CMD-HD Replica Design by toms01

A board review on revision 1.2 by M.Kanet / June 2021

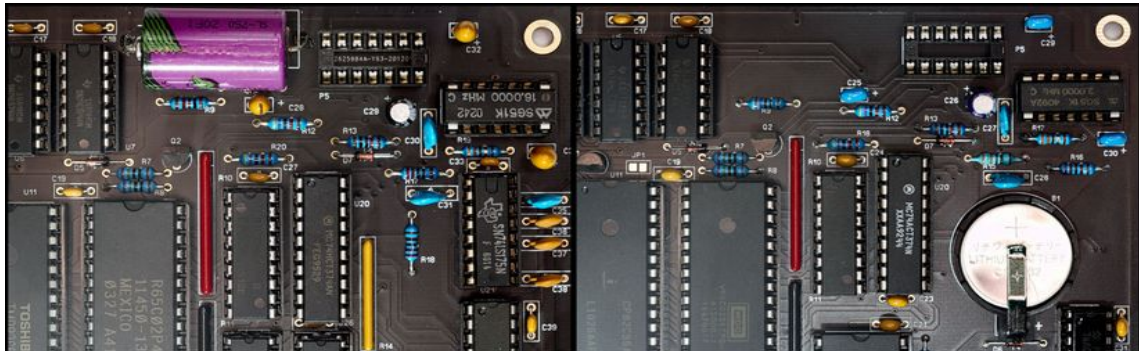
The biggest change might be the change from a fixed battery to a battery holder for a CR2032. This allows to replace the battery for the internal RTC real-time clock if needed. On the left the revision 1 with the fixed battery, on the right the revision 1.2 with the new CR2032 battery holder (Figure-03).

Also the clock (top right of the picture) could be reduced from 16Mhz to 2Mhz.

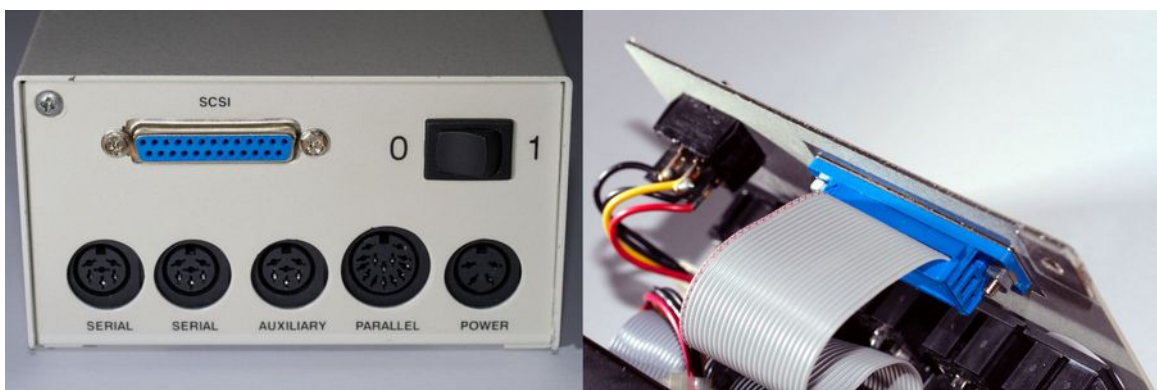
For this test I was also provided with the front panel and the DB25 SCSI connector (Figure-04):

- Left/green the original board, below in black the replica.
- Right/top the original DB25 connector female/male threaded screw. This allows the screws of a DB25 connector to be attached to the housing.
- Right/bottom the replica. To fix the DB25 socket in the housing I used screws+nuts.

Here are some more pictures. The LEDs on the front panel (Figure-12):

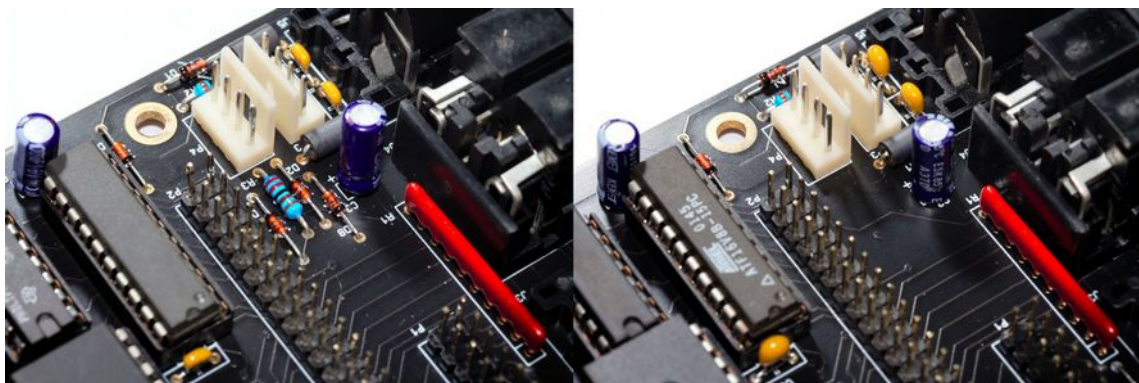
On the original board the LEDs were soldered individually, i.e. with different distance to the board itself. As you can see on picture 10, it might make more sense to install the LEDs directly on the board: On my HD, the LED had permanently pressed through the foil over the years.

The original board in my CMD-HD also required additional spacer rings: The spacer sleeves alone did not provide the correct distance to the front panel.

If the distance is too small, then the buttons are constantly under "pressure". If the distance is too large, then the buttons can no longer be pressed in. Every millimeter counts here.

After consultation with the developer, further optimizations were carried out (Figure-14):

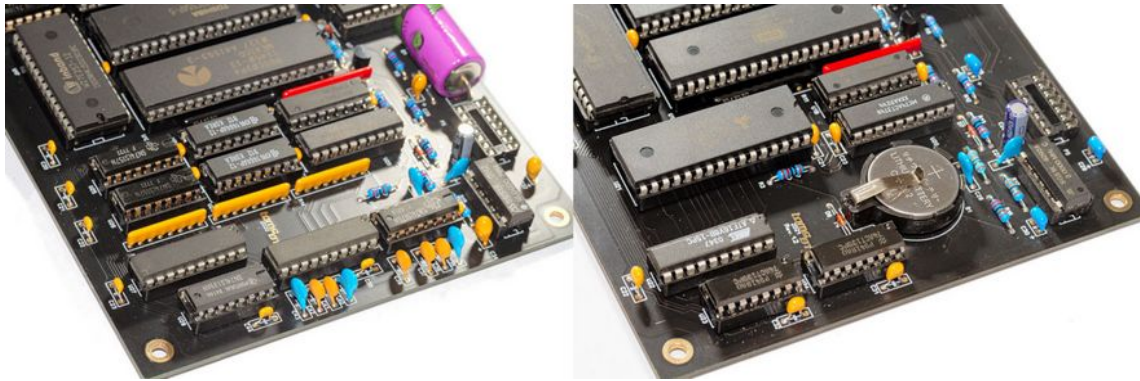
DRAM to SRAM (swapped) and then the multiplexers etc. fell out. And also the resistor networks. This also allowed the one GAL to be replaced by discrete logic (only two GALs in total). Among other things, a design flaw in the use of the clock backup battery was also fixed. This should now last longer and not unnecessarily "power" other areas when the drive is off.

Some components were also "moved" or became necessary due to the previously mentioned optimizations (Figure-15):

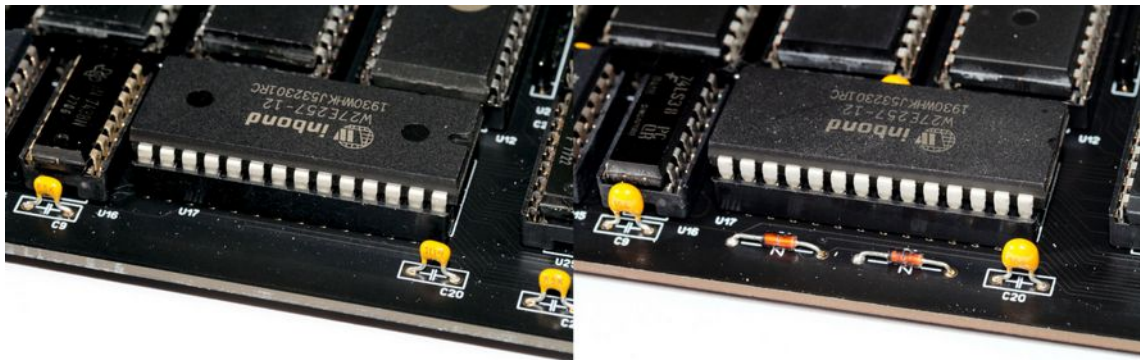
The shown changes are needed so that both types (N/S) of the currently manufactured VIA W65C22 from WDC can be used.
